Model: Bellini		Date: 31-Jan-00	No.: MA294001
Modified Article: Parts Catalog		Prepared by: H. K.	
From: Technical Services Dept., GTS Division			
Reason for Modification:	☒ Parts catalog correction ☐ To facilitate assembly ☐ Part standardization	☐ Vendor change ☐ To improve reliability ☐ Other	☐ To meet standards ()

Model: Bellini		Date: 29-Feb-00	No.: MA294002
Modified Article: Rear Fusing Plate & Right Lower Fusing Stay		Prepared by: H. Kobayashi	
From: Technical Services Dept., GTS Division			
Reason for Modification:	☐ Parts catalog correction ☐ To facilitate assembly ☐ Part standardization	☐ Vendor change ☒ To improve reliability ☐ Other	☐ To meet standards ()

Figure 1

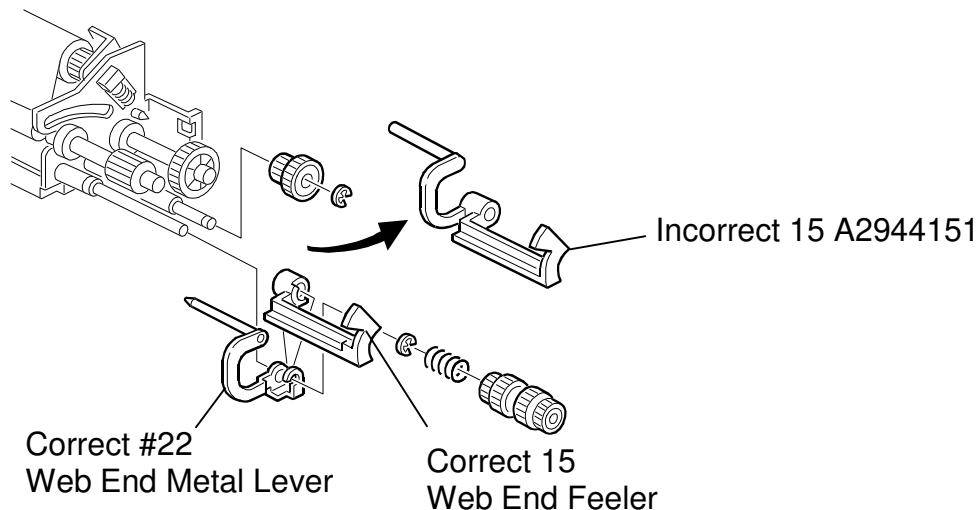
Please correct the illustration on page 100 as shown.

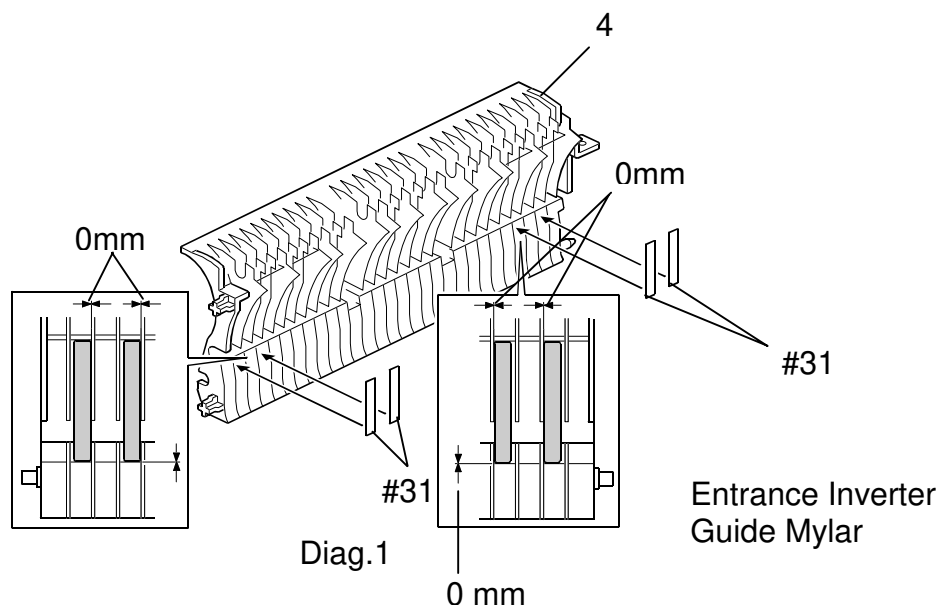
Please correct the illustration on page 110 as shown.

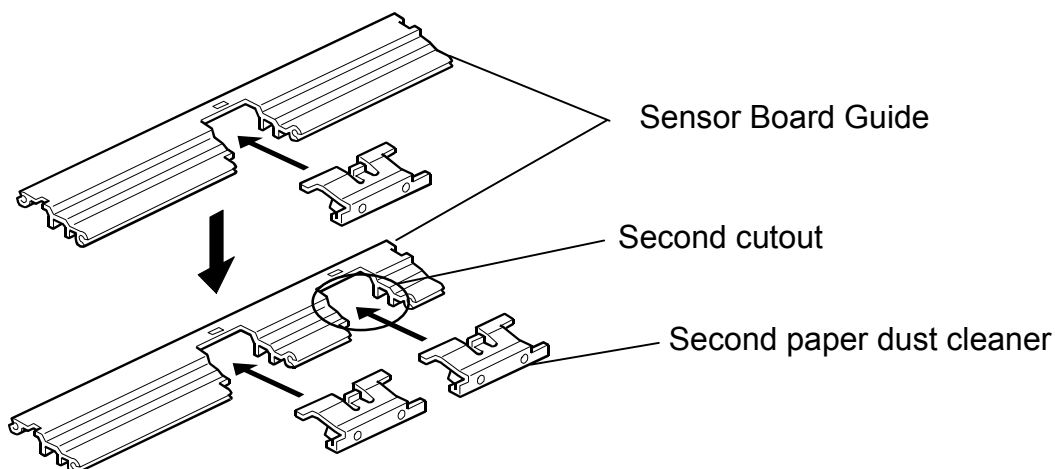
1. A second cutout has been added to the sensor board guide (see below).
2. A second paper dust remover (Paper Dust Cleaner) has been added to the rear of the sensor board guide.

Note: Since there are other parts already attached to the front side, the paper dust cleaner was attached to the rear side.

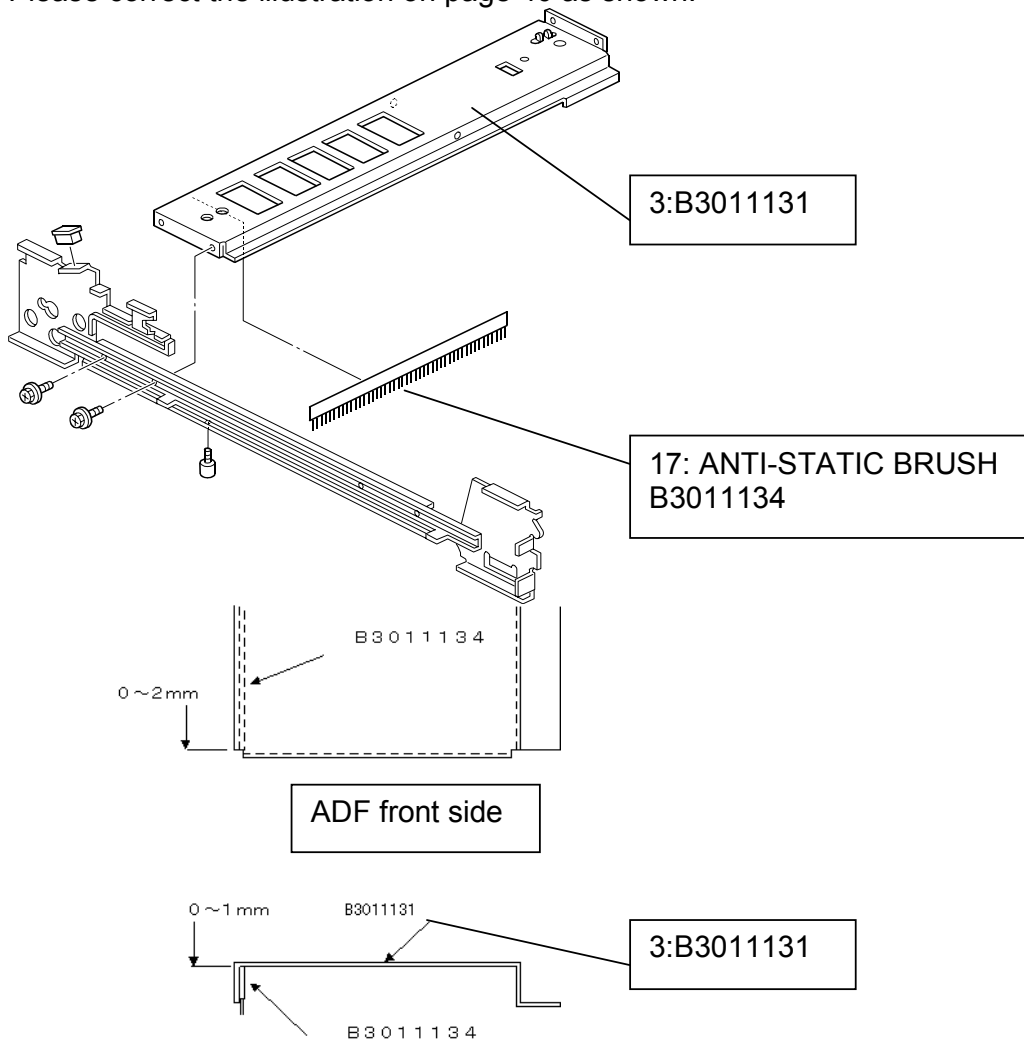
Please correct the illustration on page 40 as shown:

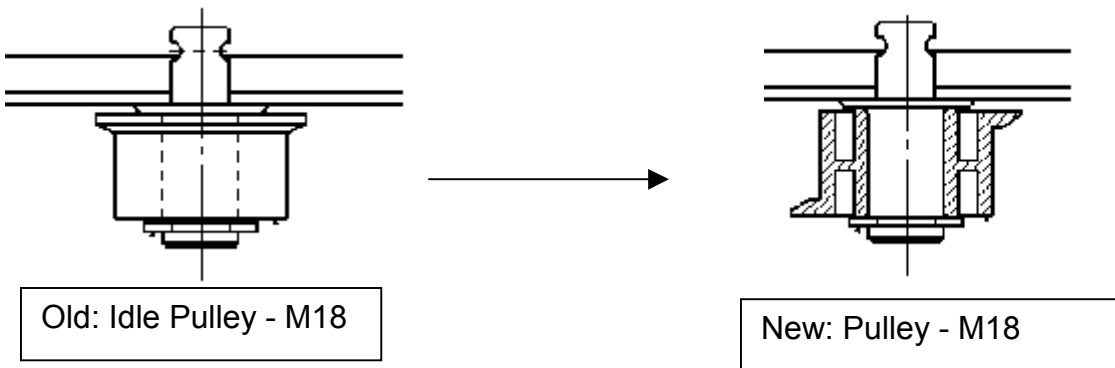
To ensure proper rotation of the timing belt, one flange has been attached to either side of the pulley. Previously, there was only one flange.

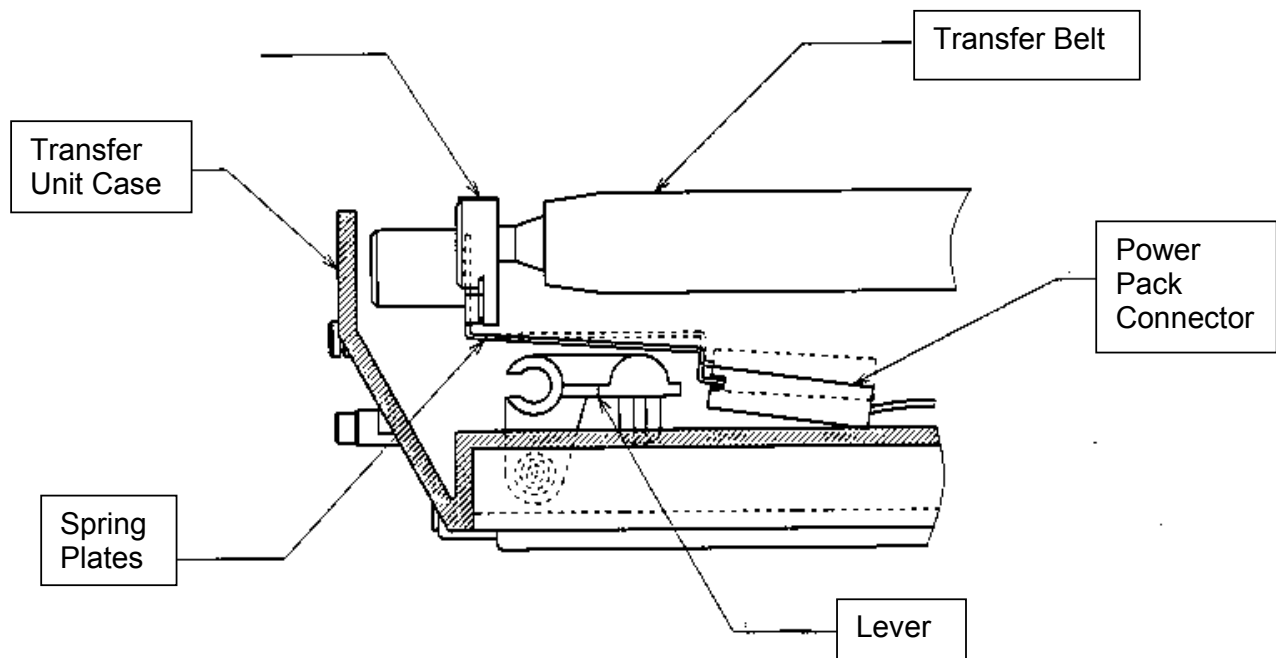
In the domestic field, the spring plates were sometimes bent downwards and the transfer belt was not released from the drum after the copy job finished. To reduce the possibility of this symptom, the production machines have been modified as follows:

Drawing No.1 Page 112

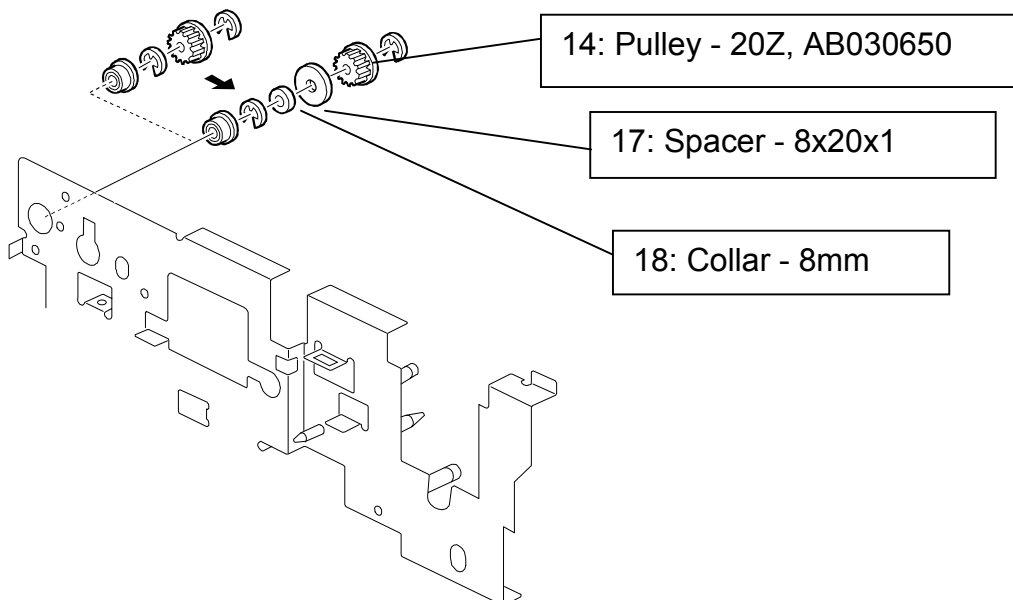
Please add the index numbers to page 112 in your part catalogue as shown.

Drawing No.2 Page 110

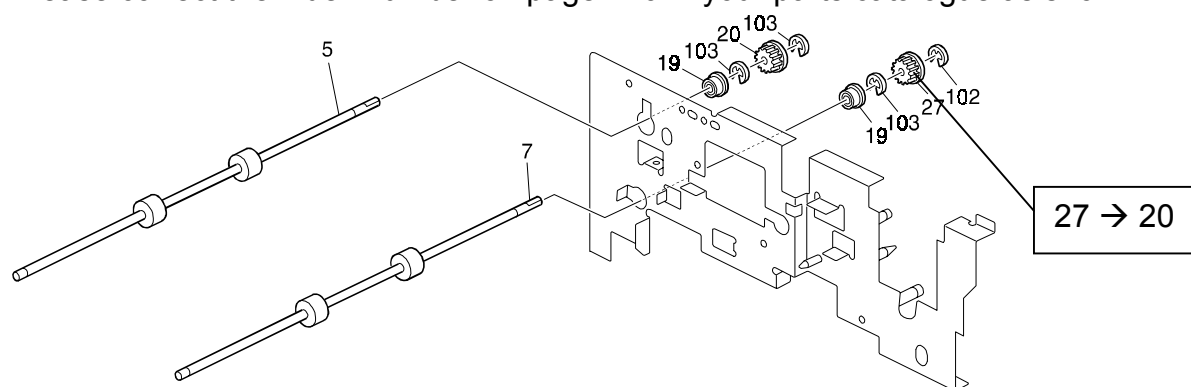
Please correct the index number on page 110 in your parts catalogue as shown.

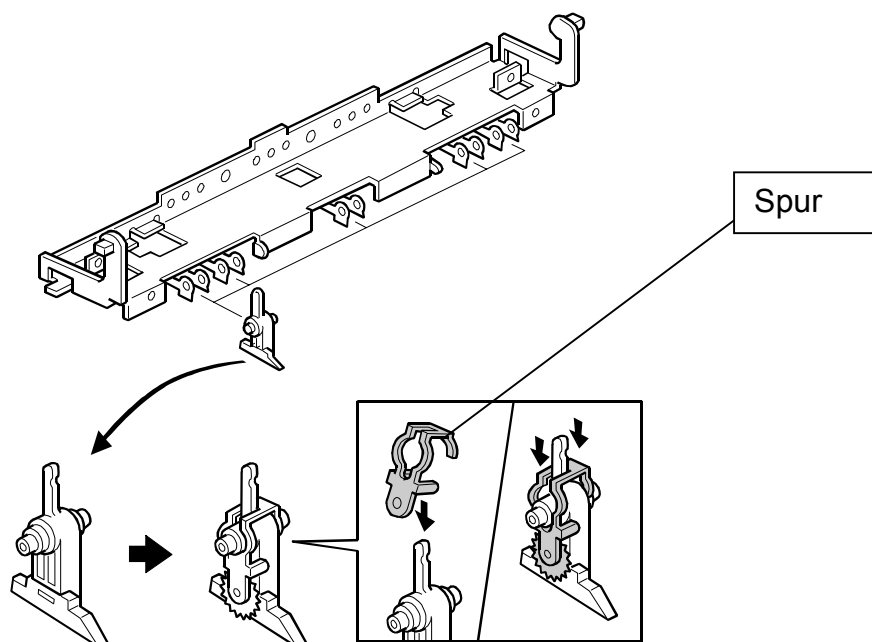
Copy paper that tends to curl easily can touch the Hot Roller Strippers when exiting the Duplex Unit the second time. As a result, some toner may be left on the surface of the strippers and rub off onto the next copy, causing black lines to appear on the side face of the copy stack. To ensure proper copy quality, a spur has been added to each hot roller stripper as shown:

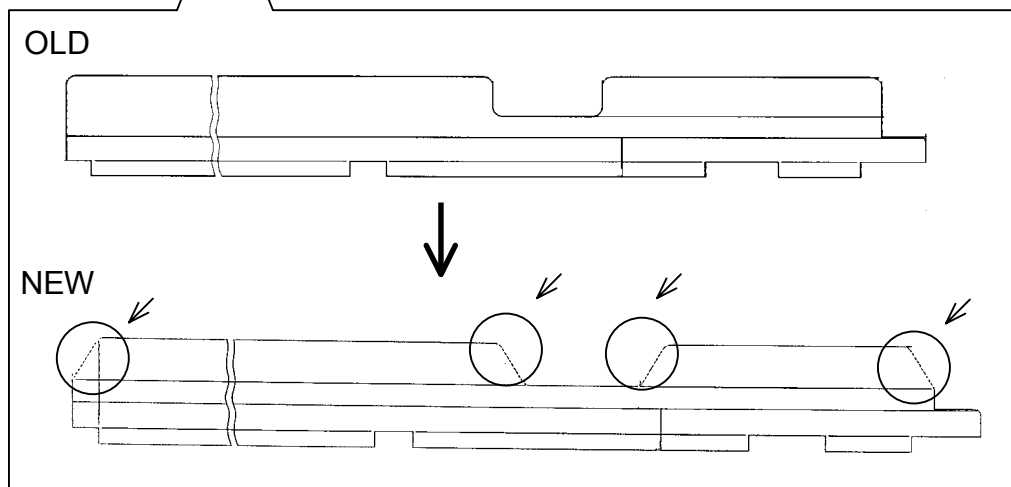
The shape of the ADF original entrance guide has been changed to reduce paper dust from the original.

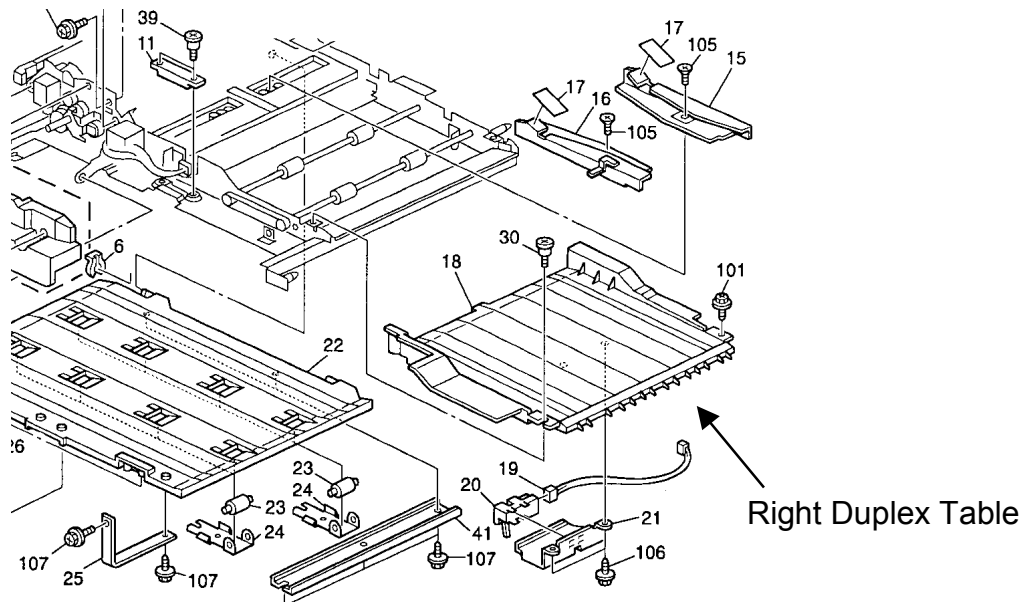
Two ribs with DLT side-ways width have been added to the Right Duplex Table to prevent DLT sideways paper skew.

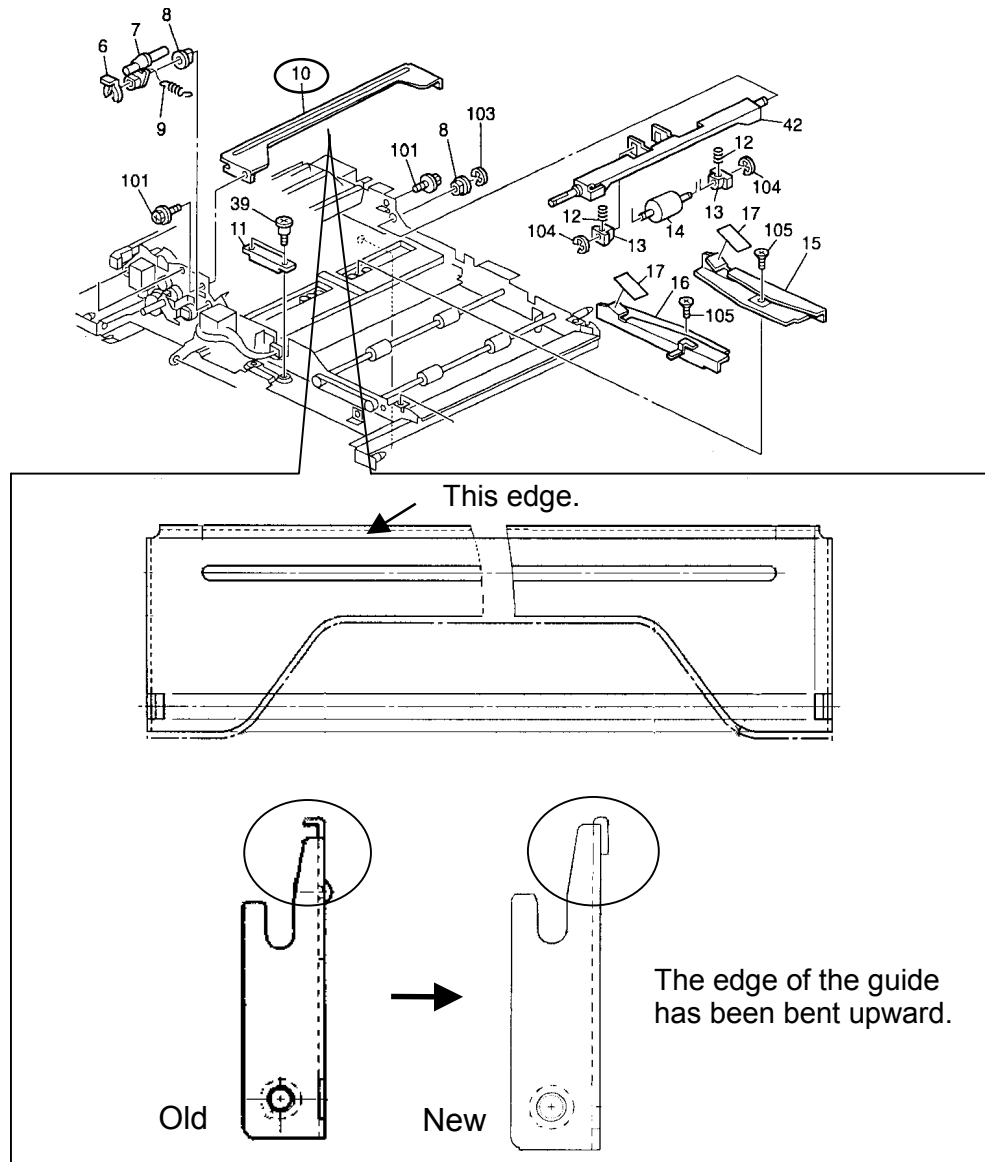
The shape of the Upper Duplex Stay has been changed as shown in the illustration below to reduce the noise when the entrance guide (Page 119, Index 18) contacts the stay.

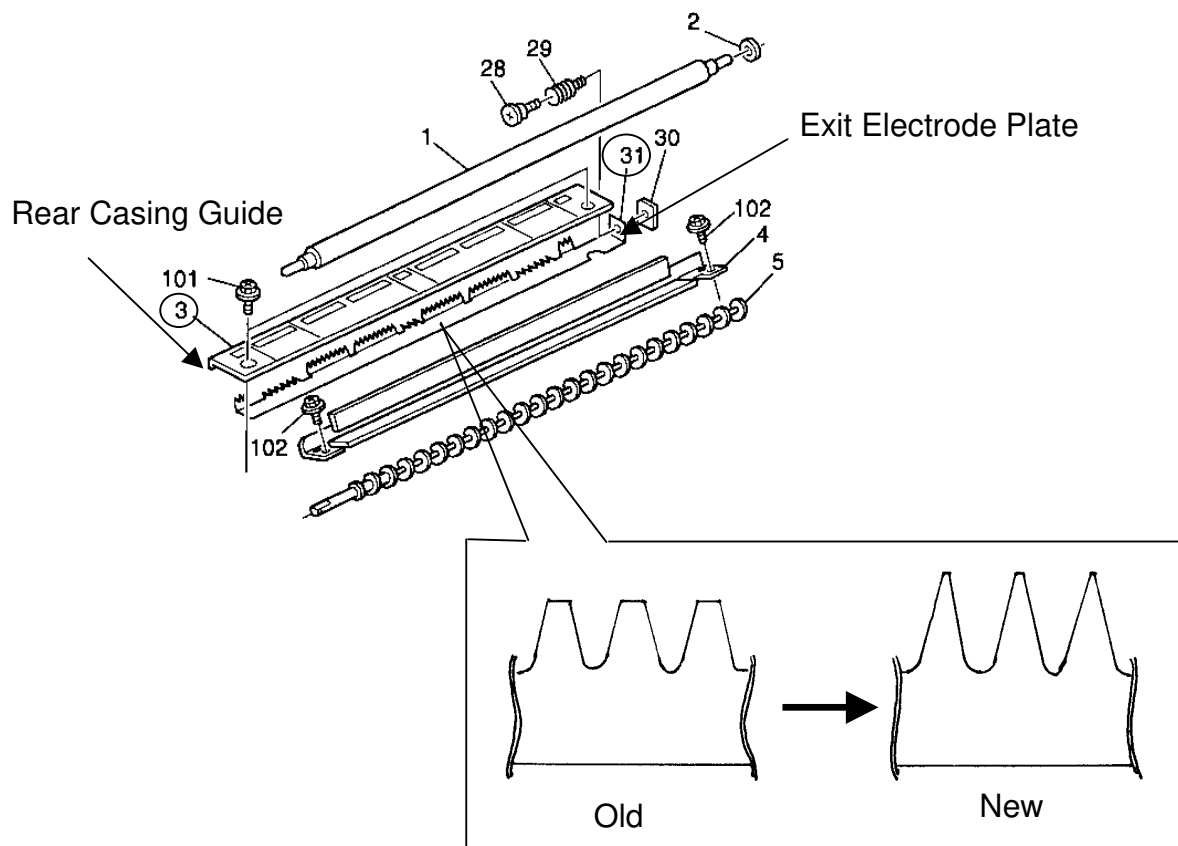
The material of the Rear Casing Guide and the shape of the Exit Electrode Plate have been changed to improve the dirty side edge problem. Each old part can physically be replaced with the new one, but to prevent side effects from affecting the copy, these parts should be replaced at the same time.

The details of the shape change of the electrode are shown below.

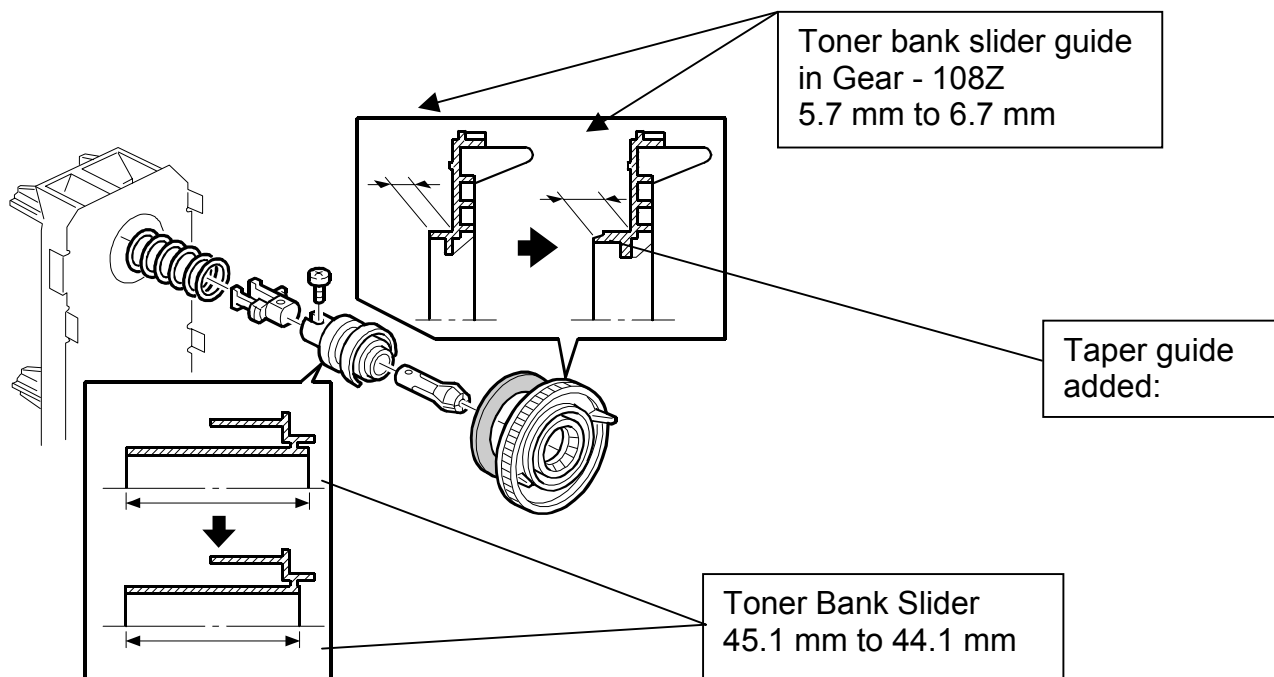
1. The length of the toner bank slider has been reduced from 45.1 mm to 44.1 mm.
2. The length of the toner bank slider guide in gear 108Z has been increased from 5.7 mm to 6.7 mm.
3. A taper guide has been added to each toner bank slider and to gear-108Z.
4. Due to this modification, the part numbers of the toner bank unit have been changed.

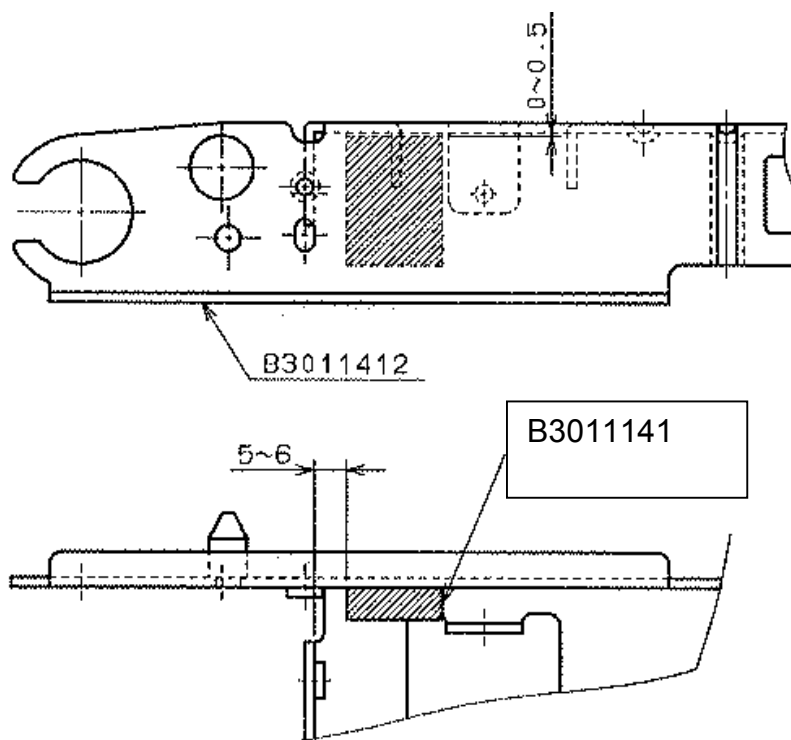
To absorb noise from the transport belt rear stopper during the production line test, a rubber cushion has been added to the transport belt unit (13: B3011412).
